Item Name: Replacement Skidtube, Low & High Gear with Standard Wearplates Fits LH or RH

DRAWING NO. D2650	TITLE 206/407 SKIDTUBE ASSEMBLIES	REV. F	DART AEROSPACE LTD ENGINEERING ORDER		D.E.O. NO. D2650-F-1	SHEET NO. SHEET 1 OF 1	SCALE NTS
DRAWN <i>[Signature]</i>	CHECKED A.P.	MFG. APPR. <i>[Signature]</i>	APPROVED <i>[Signature]</i>		DE APPR. <i>[Signature]</i>		
DATE 12.10.12	DATE 12.10.22	DATE 12.10.22	DATE 12.10.22		DATE 12.10.22

CHANGE C'BORED WELDED CROSSBOLT SPACERS TO SWAGED SPACERS

DETAIL G

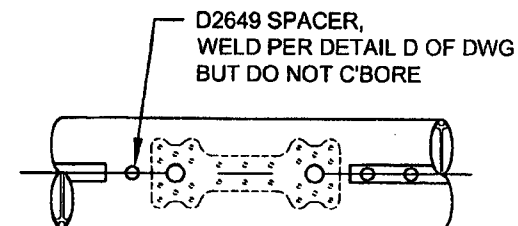
ADD DETAIL G BELOW, WHICH IS THE SAME SECTION VIEW AS DETAIL D OF DWG.

C'BORED HOLES ARE **NOW SWAGED** PER DETAIL G BELOW. FOR THE Ø0.375 HOLE THAT IS NOT C'BORED, WELD PER DETAIL D OF DWG (SEE AMENDED DETAIL B FOR REFERENCE).
